DOCUMENT 00 90 00
ADDENDUM

ADDENDUM No.: 1

DATE: September 19, 2024

RE: VIROQUA HOUSING AUTHORITY
PUBLIC HOUSING PROJECT WI 118
200 PARK VIEW COURT
VIROQUA, WI 54665
PROJECT NO. 24012

E100

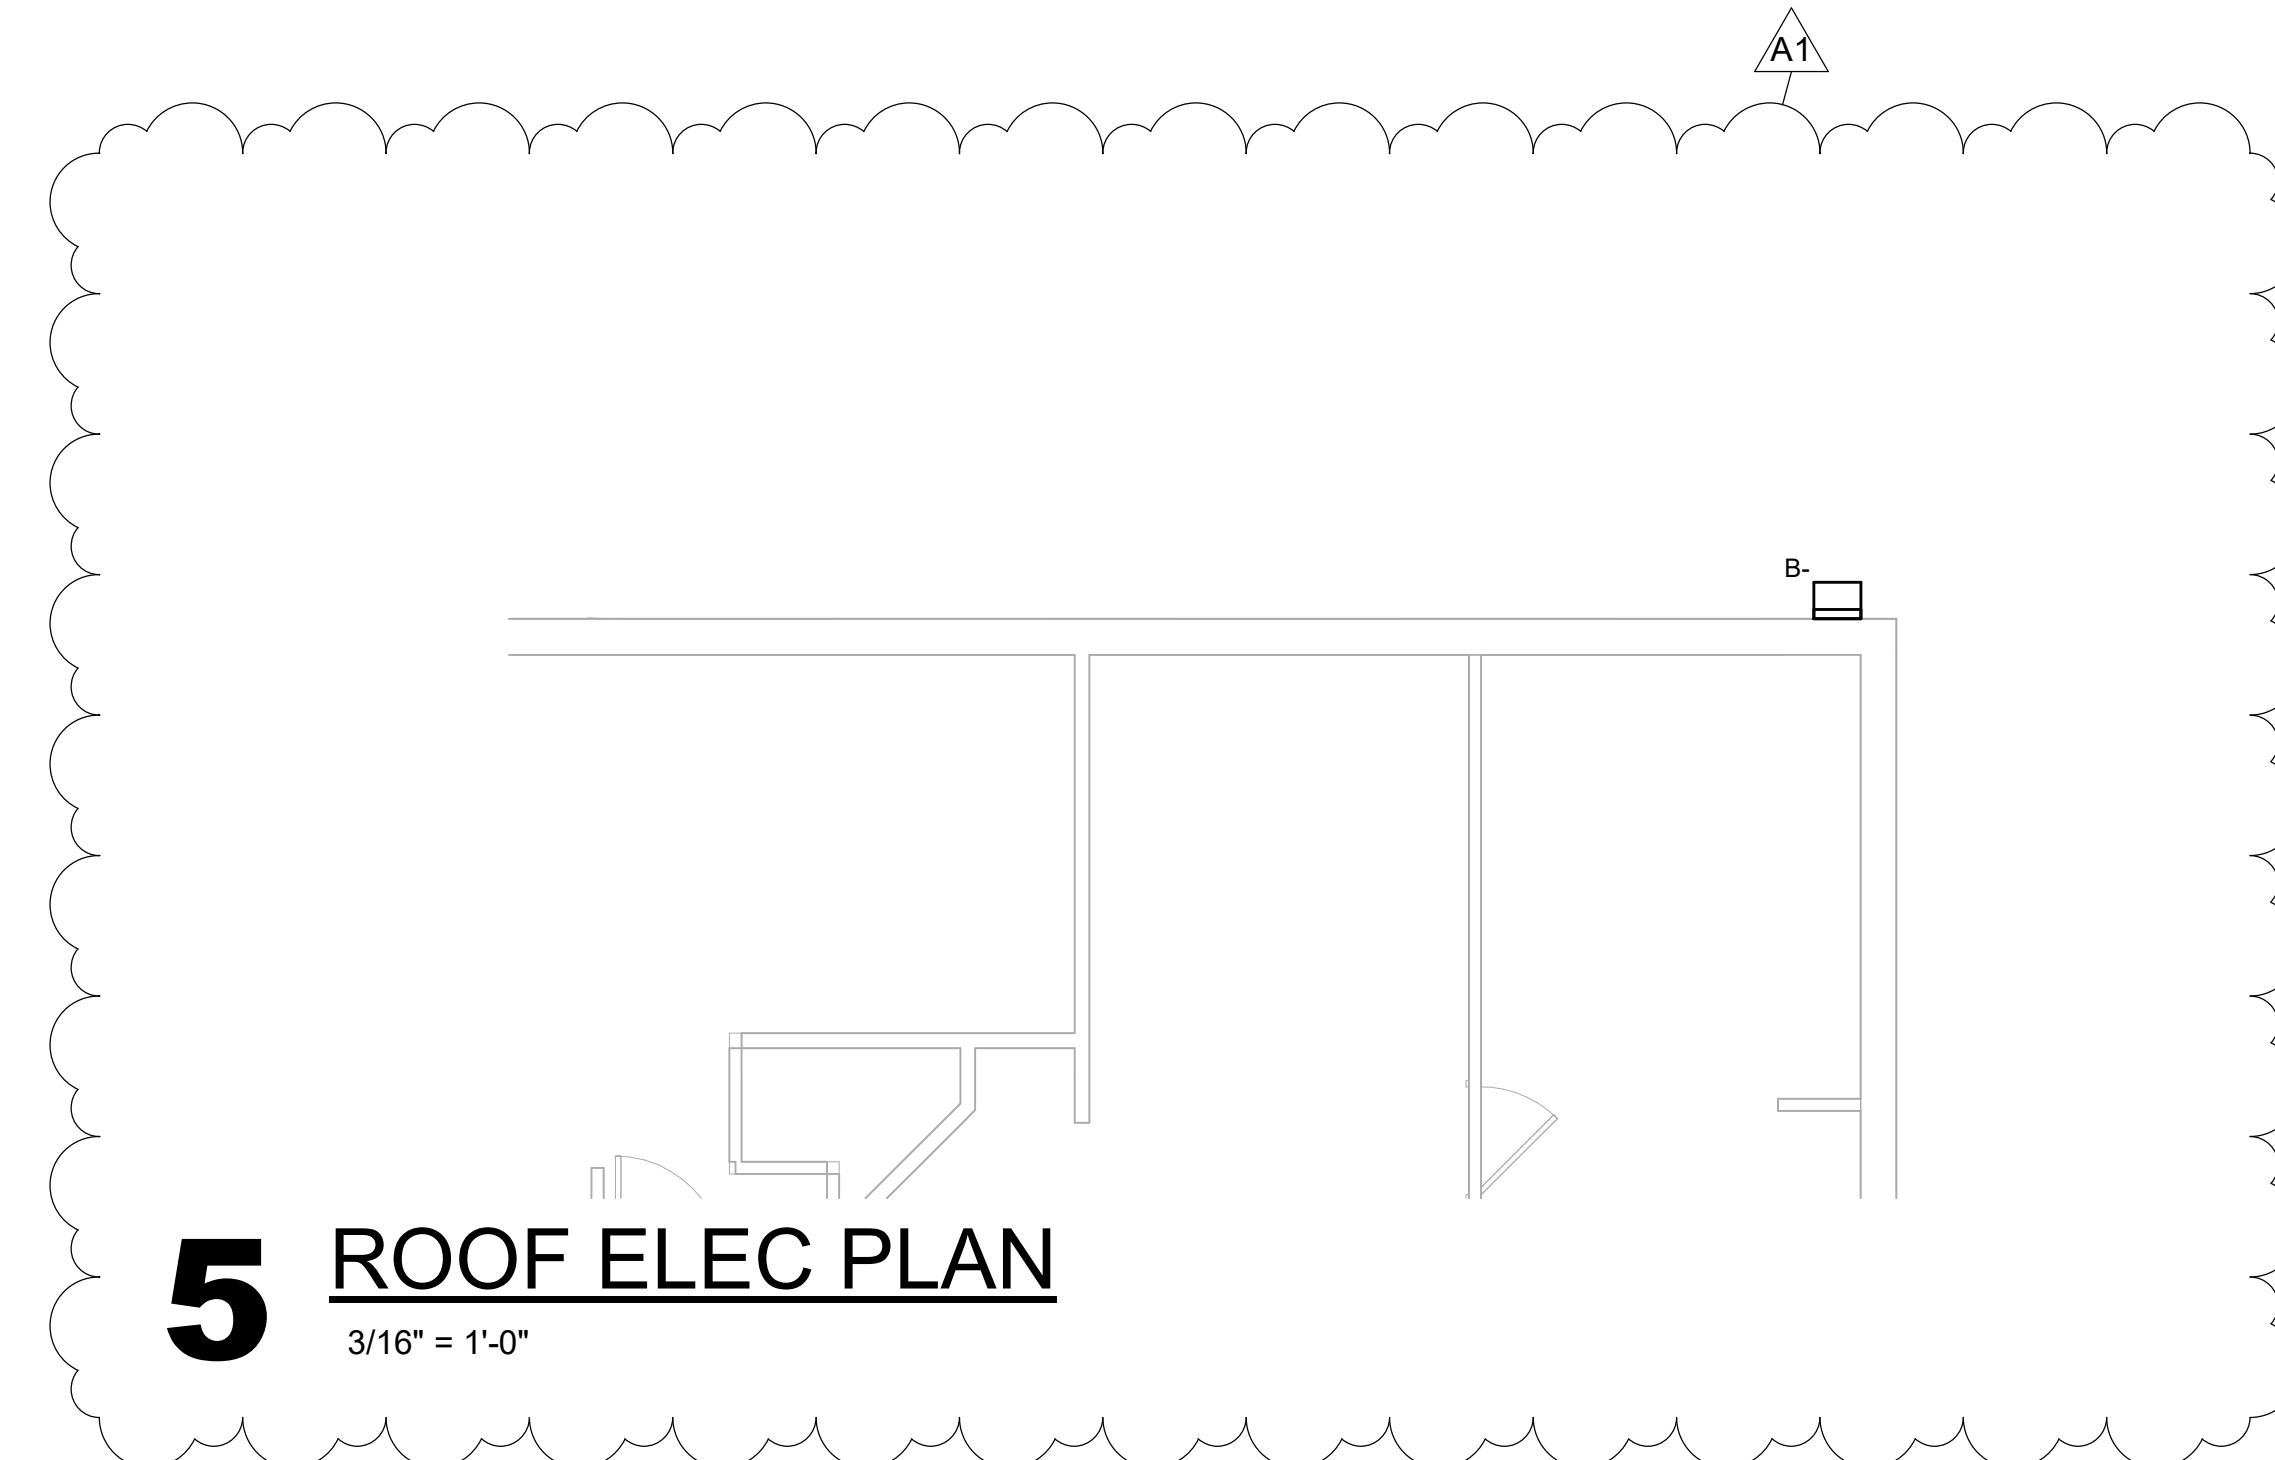
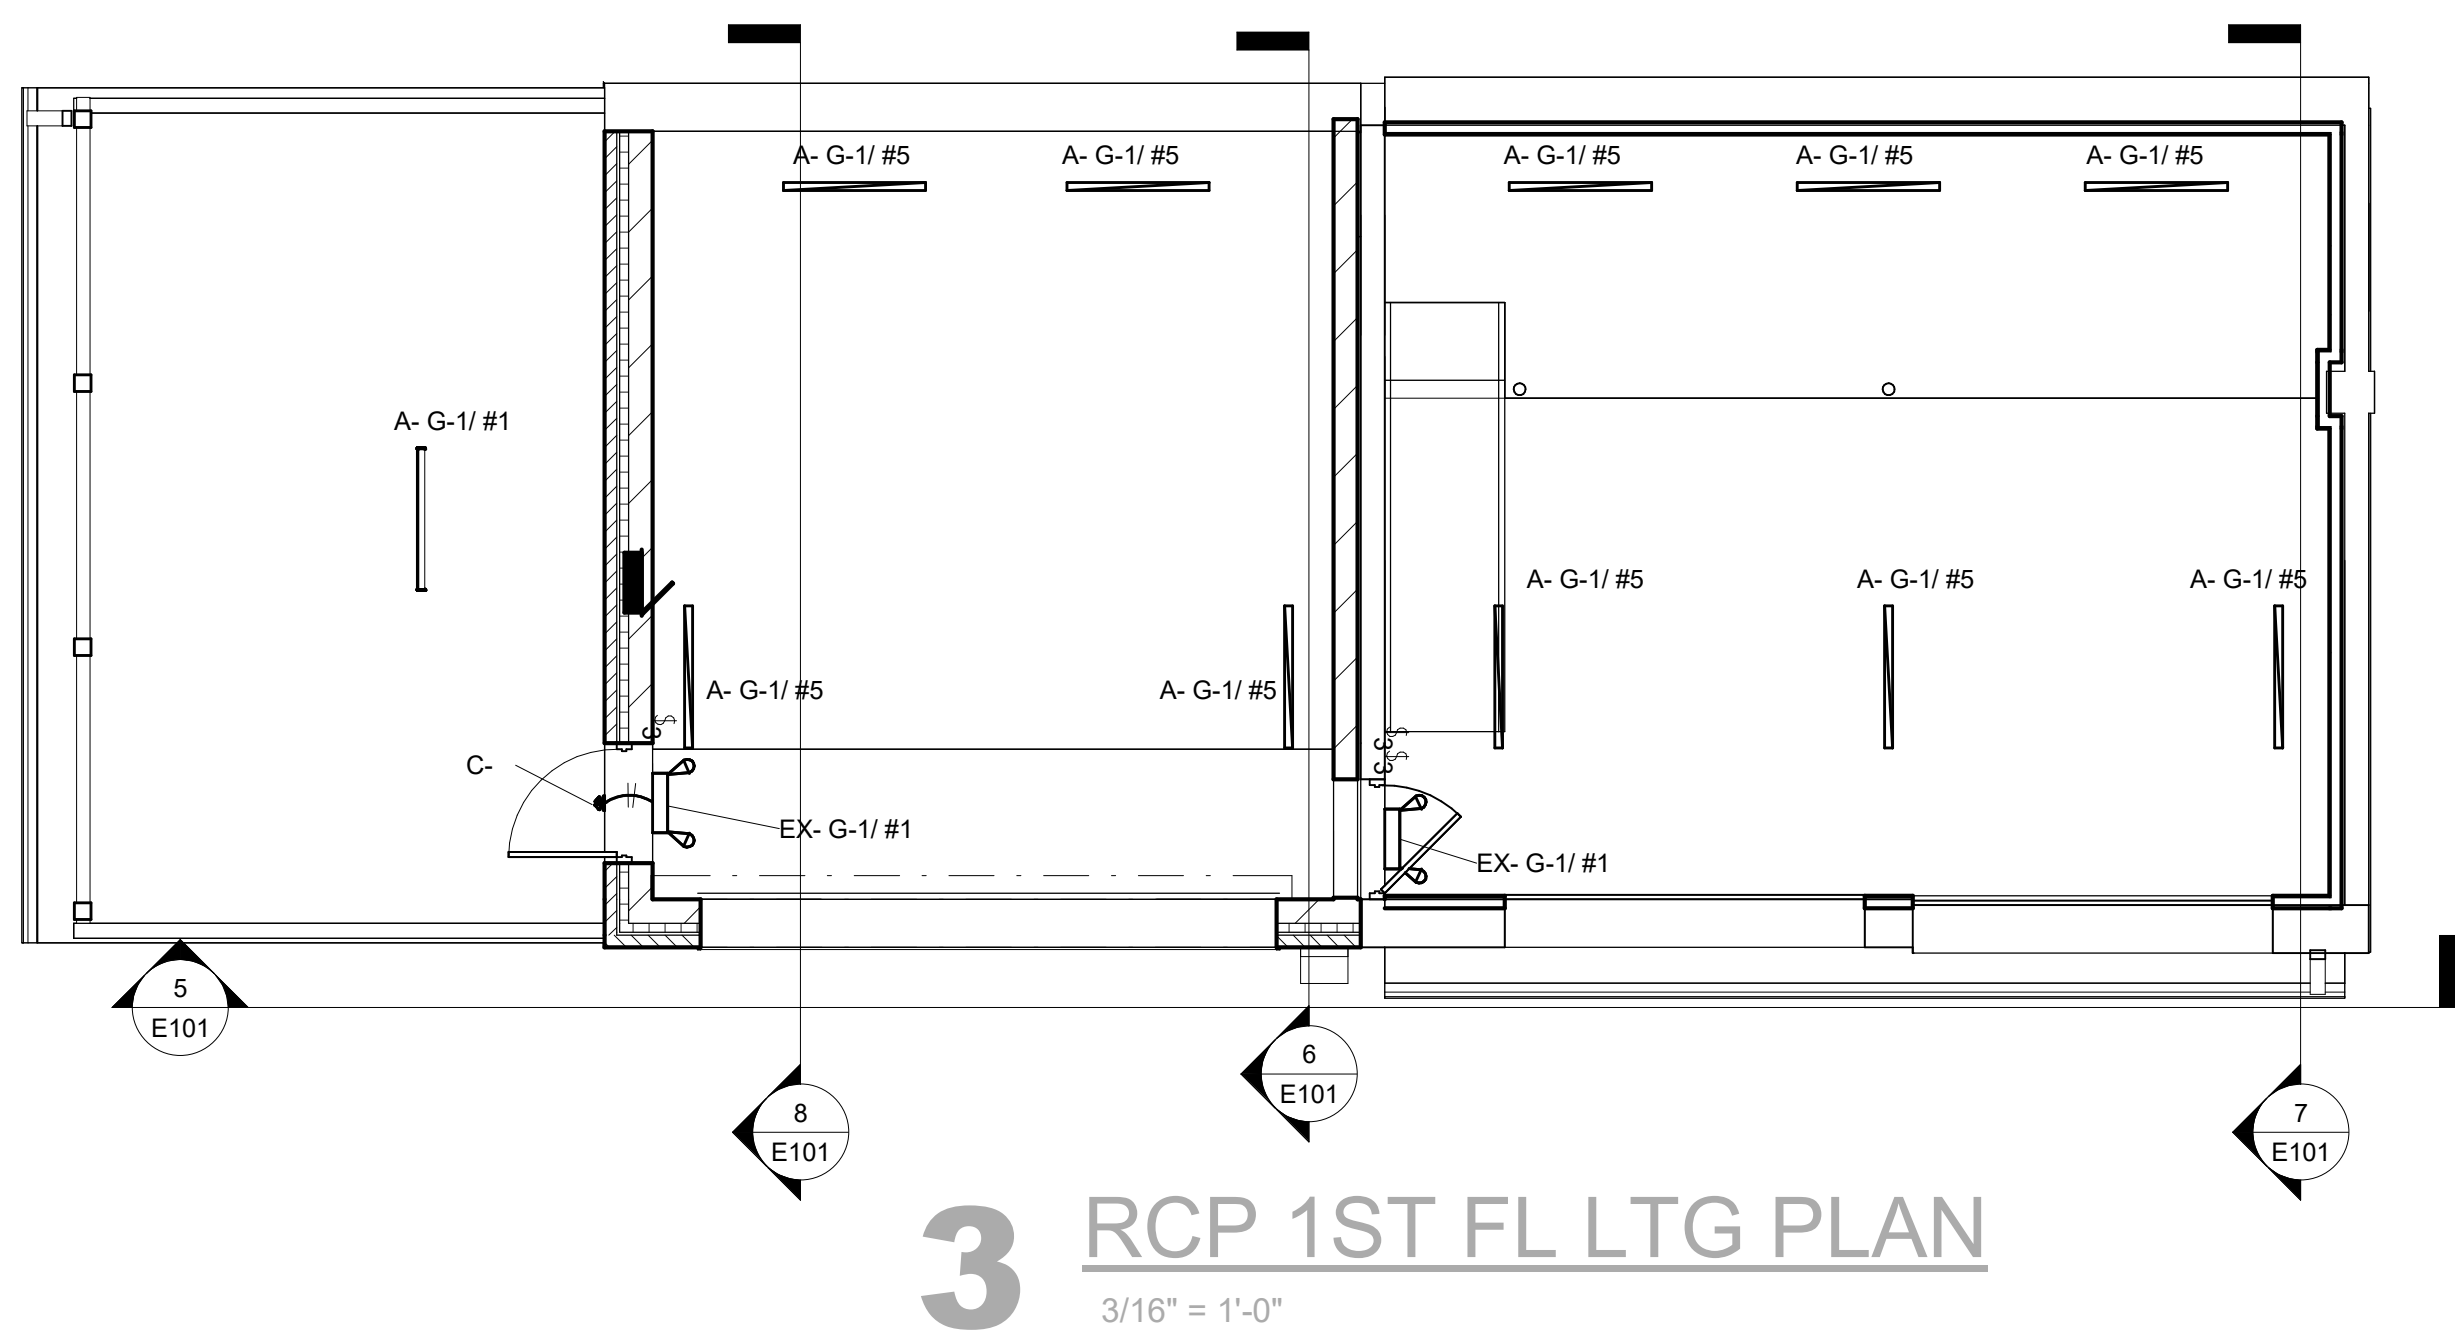
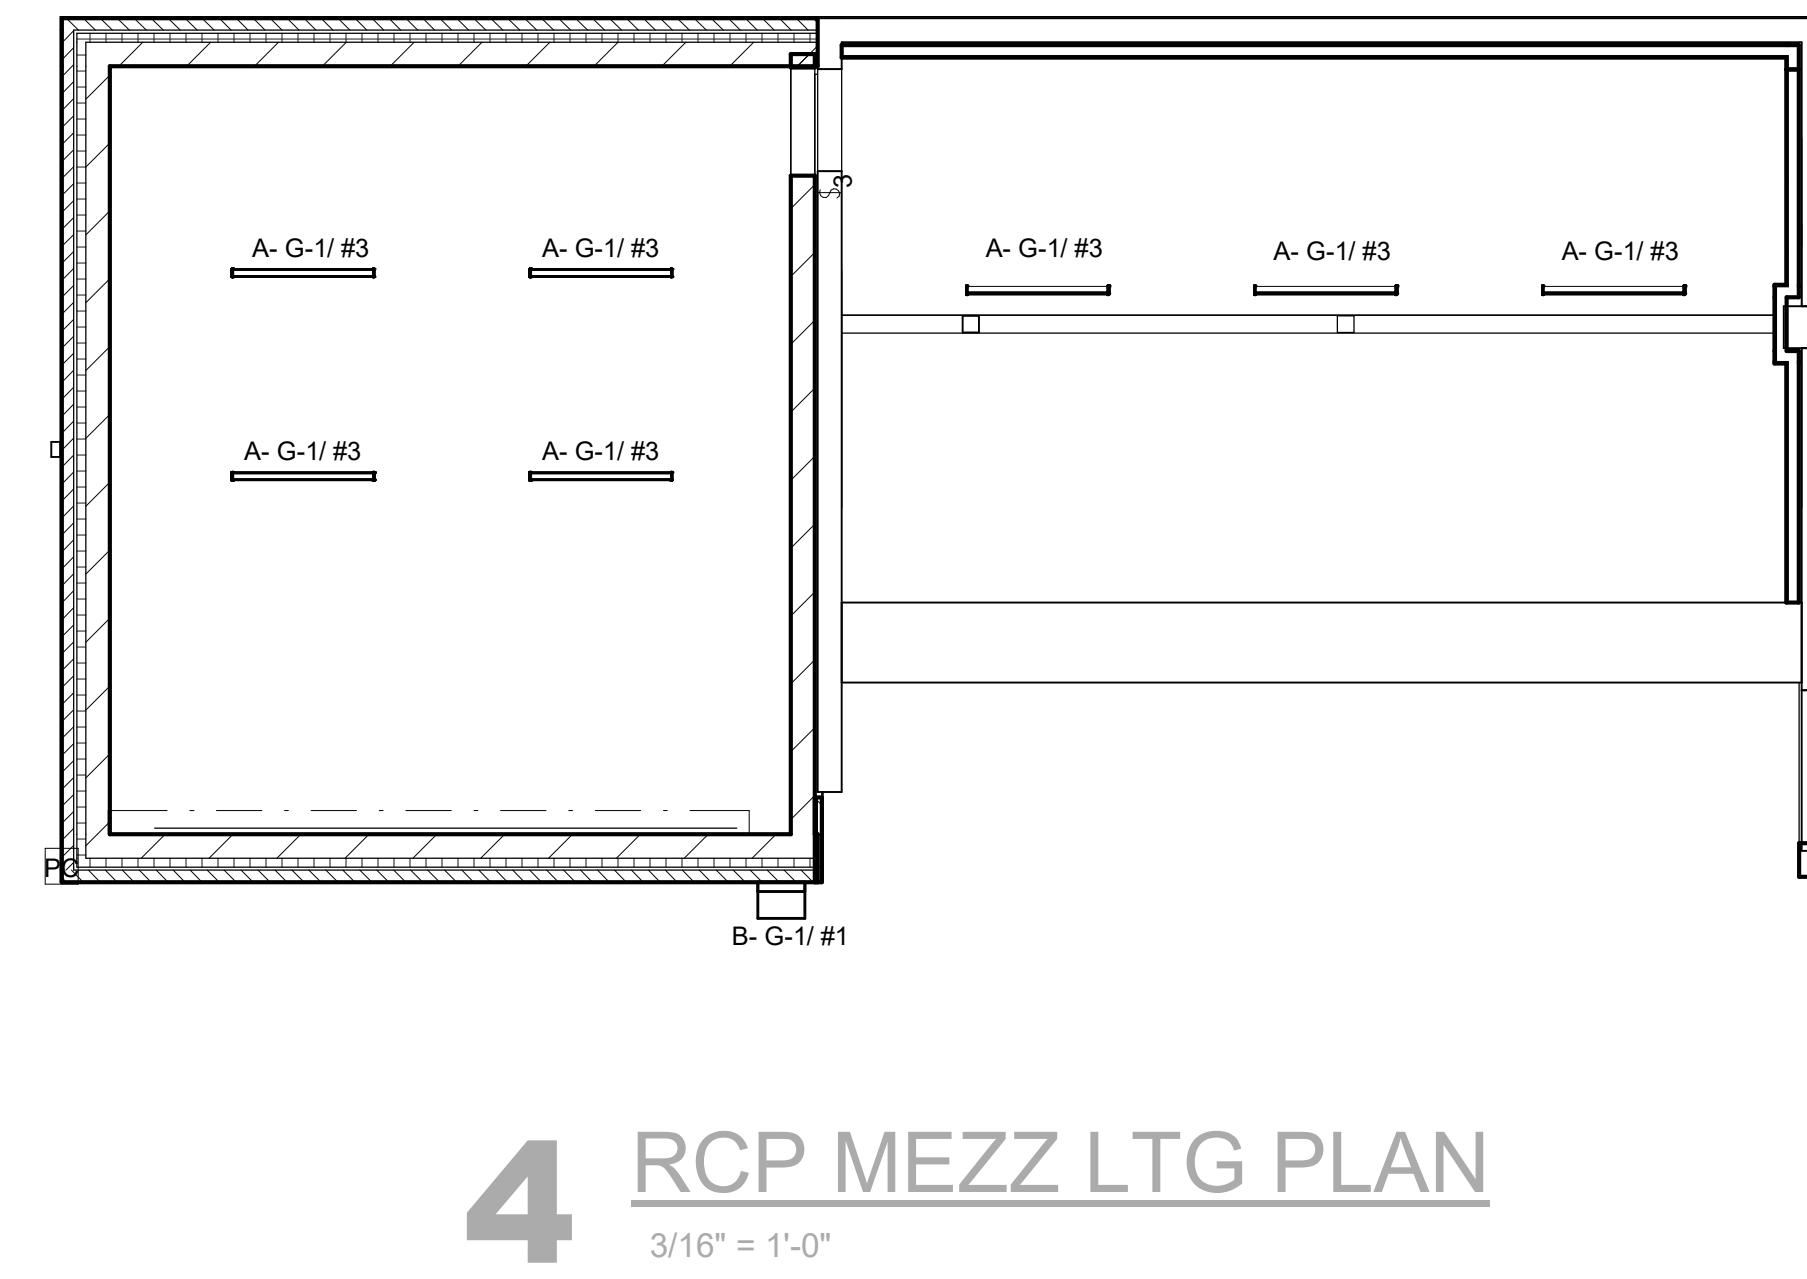
- b. Added Roof Elec Plan.
 - c. Added plan to show location of panelboard A1.
14. Sheet E101 ELECTRICAL PLAN 30"x42"
 - a. See the revised sheet included in this addendum. Disregard the previous version.
